SUBJECT: Advises that corrective action plan for sacrificial shield wall finalized. Forwards Burns & Roe Technical Memo 1173 Justifying use of partial penetration welds.

Subject: WPPSS NUCLEAR PROJECT NO. 2
DOCKET NUMBER 50-397
SACRIFICIAL SHIELD WALL (SSW)
CORRECTIVE ACTION PLAN

TO R. E. Snaith
FROM M. N. Fialkow
SUBJECT W. O. 2808
Washington Public Power Supply System.
WPPSS Nuclear Project No. 2
Sacrificial Shield Wall - Assessment Program
Connection of Upper and Lower Wall Segments
TECHNICAL MEMORANDUM NO. 1173

FIGURE 1

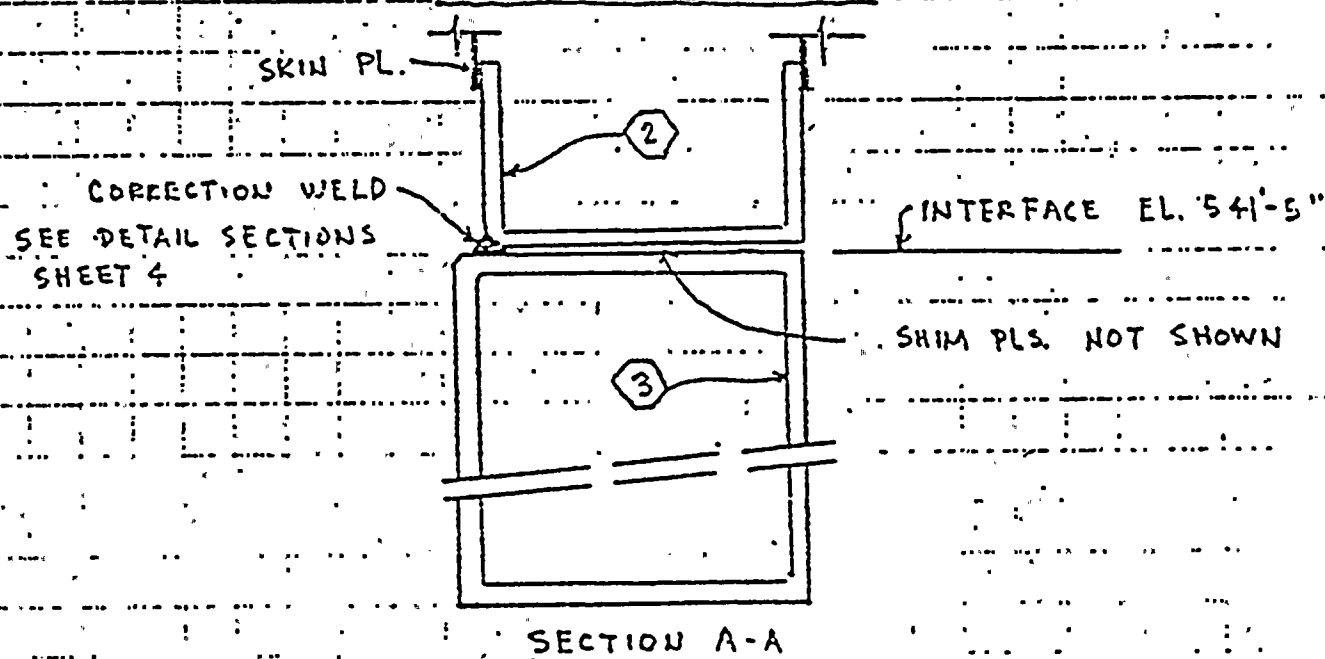
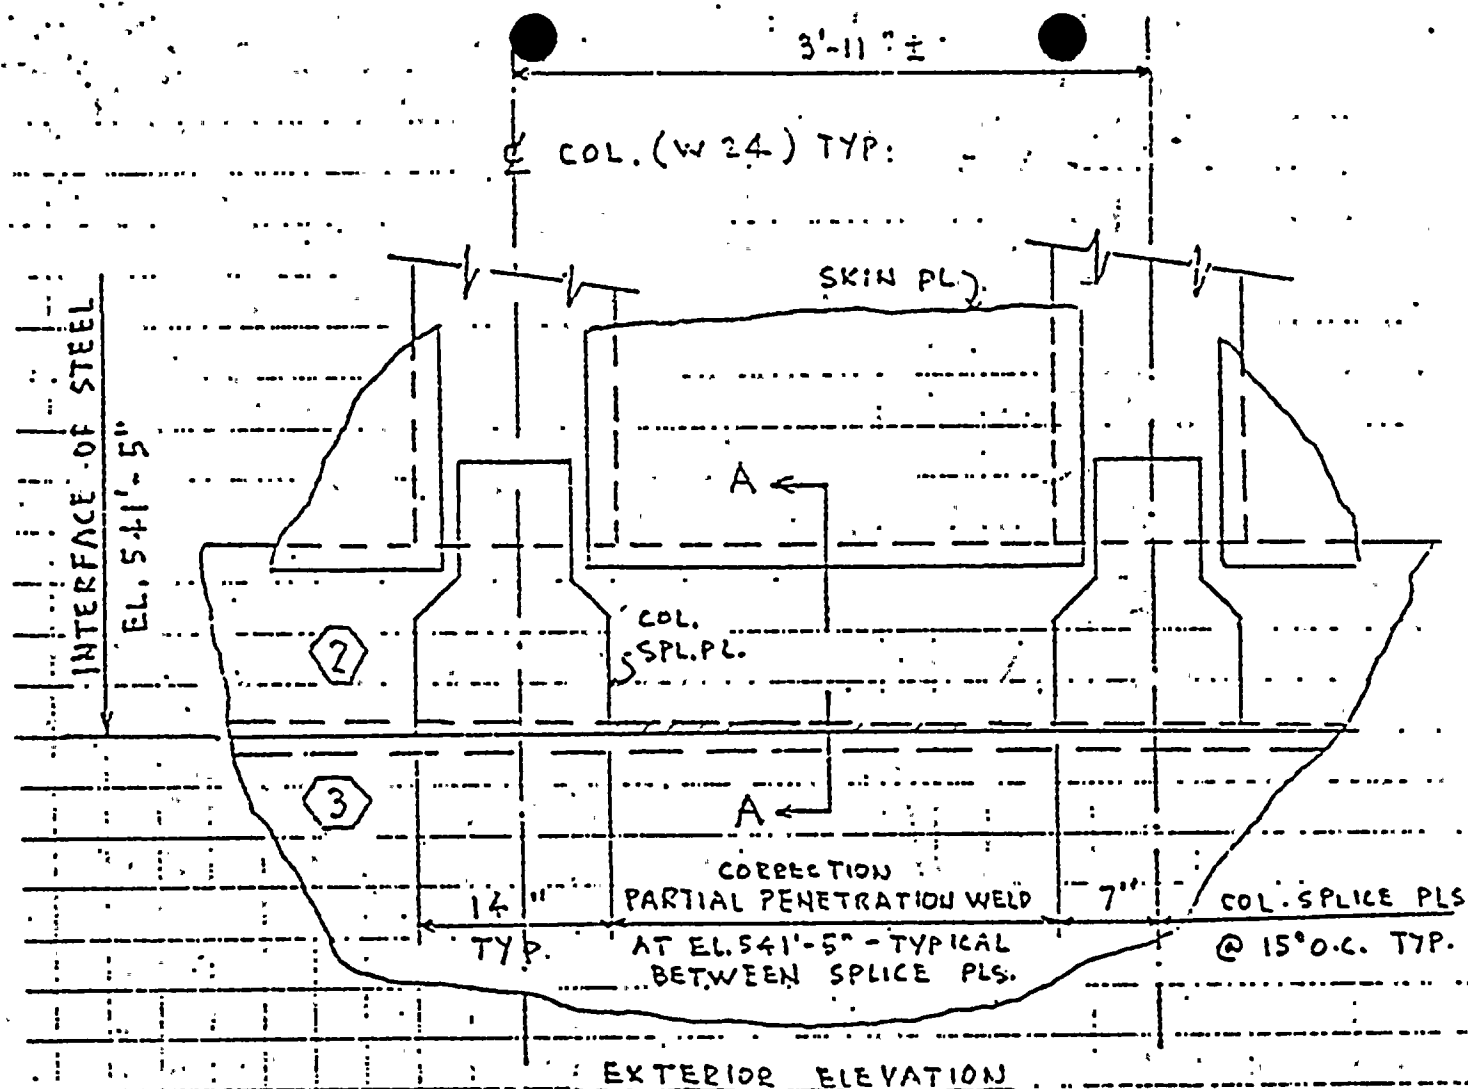
The correction weld is a partial penetration groove weld with fillet weld reinforcement to be installed along the exterior circumference between the rings above and below the interface at Elevation 541'-5". The location and extent of the weld are shown in Figure 1; weld details are shown in Figure 2.

As shown in the figures, the correction weld is to be installed in each of the 24 panels around the SSW for the width available between the column splice plates. Preparation for the groove weld requires removal of material from the channel ring. The specific configuration of the weld in each panel, including the groove depth and the size of the fillet weld reinforcement, depends on the width of ledge at the interface. From the design viewpoint, a minimum overall weld depth of 2 inches, corresponding to an effective weld throat of $1 \frac{7}{8}$ inches, is maintained in all configurations.

Based on the preceeding analysis, the proposed correction weld at interface Elevation 541'-5" has sufficient capacity to sustain the required loads. The correction provides a design margin in excess of 2.1.

FIGURE 2

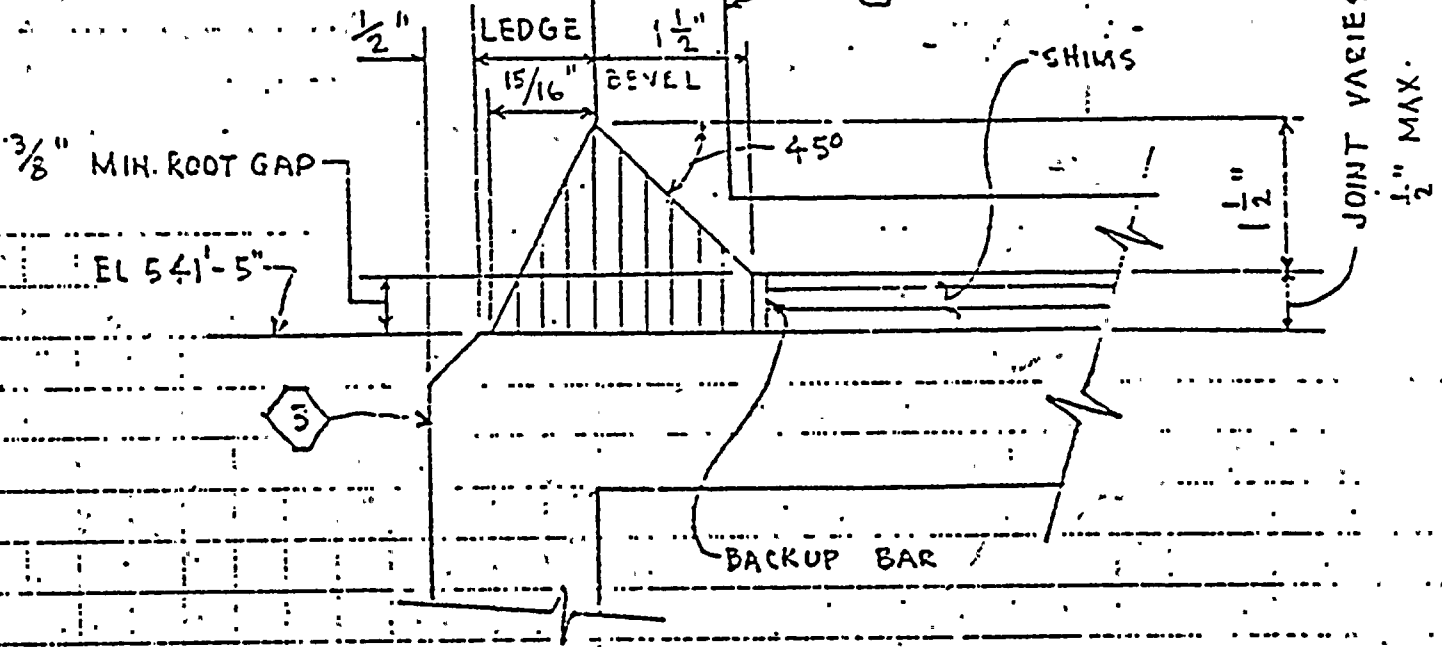
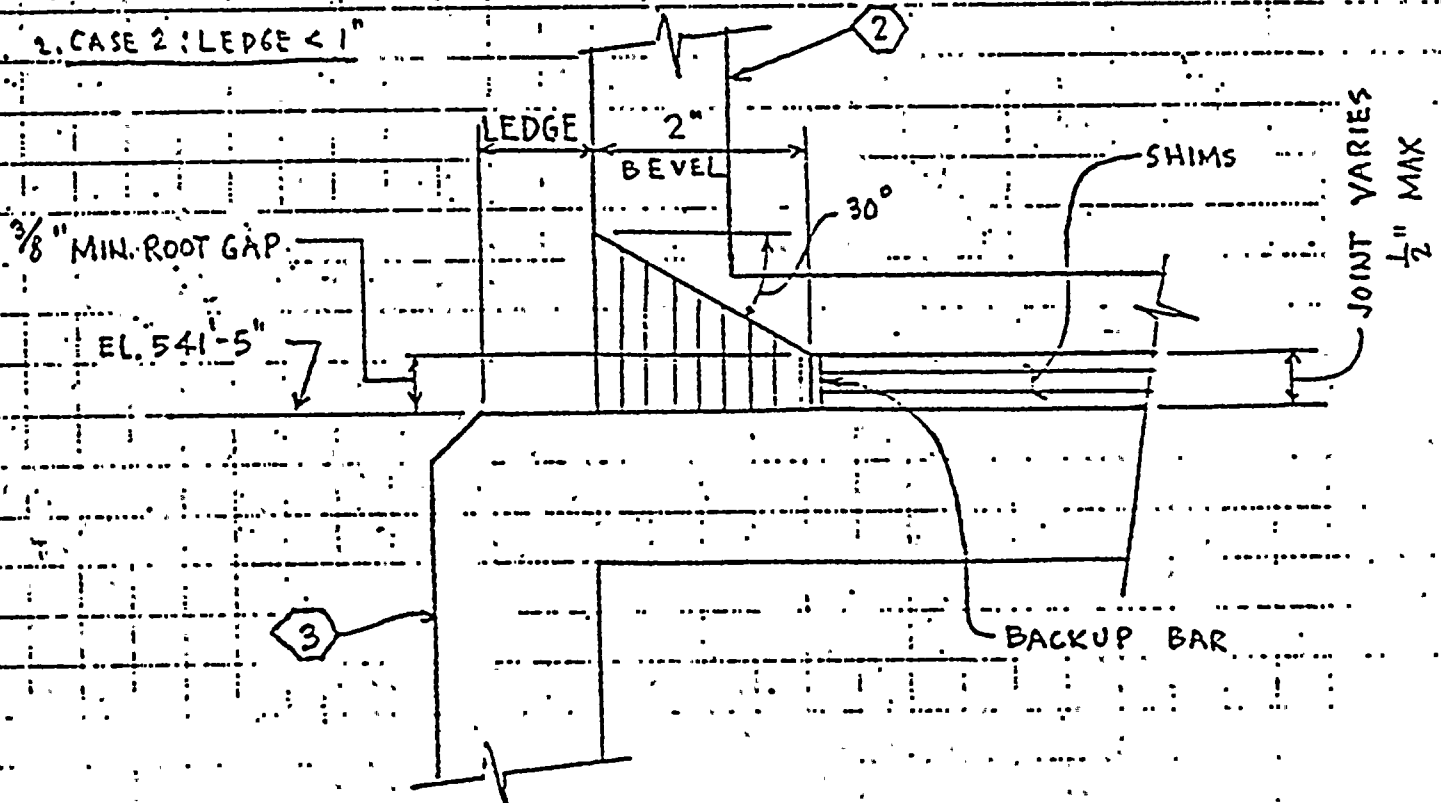
SECTION WHERE LEDGE IS A MINIMUM OF 1" WIDE

SECTION WHERE LEDGE IS LESS THAN 1" WIDE
REINFORCING FILLET TO BE ADDED AS
SHOWN ON SHEET 5 OF PED-215-CS-2741.
